APPLICATION NO.	FILING DATE	FIRST NAMED INVENTOR	ATTORNEY DOCKET NO.	CONFIRMATION NO.
10/689,706	10/22/2003	Jung Hyun Lee	2336-214	4635

Office Action Summary	Application No.	Applicant(s)	
	10/689,706	LEE ET AL.	
	Examiner	Art Unit	
	Omar Rojas	2874

DETAILED ACTION

Regarding claim 1, JP '885 discloses a MEMS (Micro Electro Mechanical System) variable optical attenuator (e.g., see Figure 4) comprising:

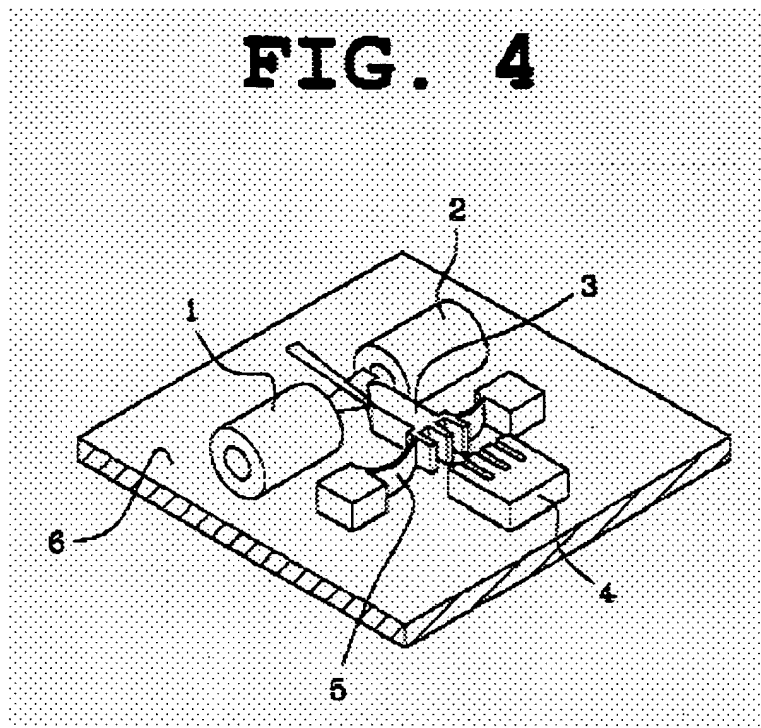
- a substrate 6 having a flat upper surface;

- optical transmitting and receiving terminals (1, 2) arranged on the upper surface of the substrate so that optical axes of the terminals coincide with each other;

- a movable optical shutter 3 arranged at a location such that it attenuates the maximum amount of light transmitted between the optical transmitting and receiving terminals;

- a micro actuator 4 arranged on the substrate for moving the movable optical waveguide;

- and a voltage supply unit (inherent, not shown) for supplying driving voltage to the micro actuator 4 , wherein the micro actuator 4 moves the movable optical shutter so that the light attenuation amount is decreased in accordance with the increase in the driving voltage applied by the voltage supply unit. See the '845 patent at column 5, line 3 to column 6, line 5. Figure 4 is reproduced below.

Regarding claim 6, the micro actuator 4 includes: a movable electrode unit arranged on the substrate and provided with a first comb unit moving in the direction perpendicular to the optical axes; and a driving electrode unit fixed to the substrate and provided with a second comb unit interdigitated with the first comb unit as seen in Figure 4.

Regarding claim 7, compare Figure 4 of JP '885 with Figure 4a of the application drawings.

Thus, JP '885 only differs from claims 1-4 and 6-7 in that a movable optical shutter is used, instead of a movable optical waveguide.

Hsu, on the other hand, teaches an optical attenuator device that uses a movable optical waveguide 36 instead of a shutter.

Therefore, it would have been obvious to one of ordinary skill in the art at the time of the claimed invention to obtain the invention specified by claims 1-4 and 6-7 by replacing the shutter taught in JP '885 with the cost effective movable waveguide taught by Hsu.
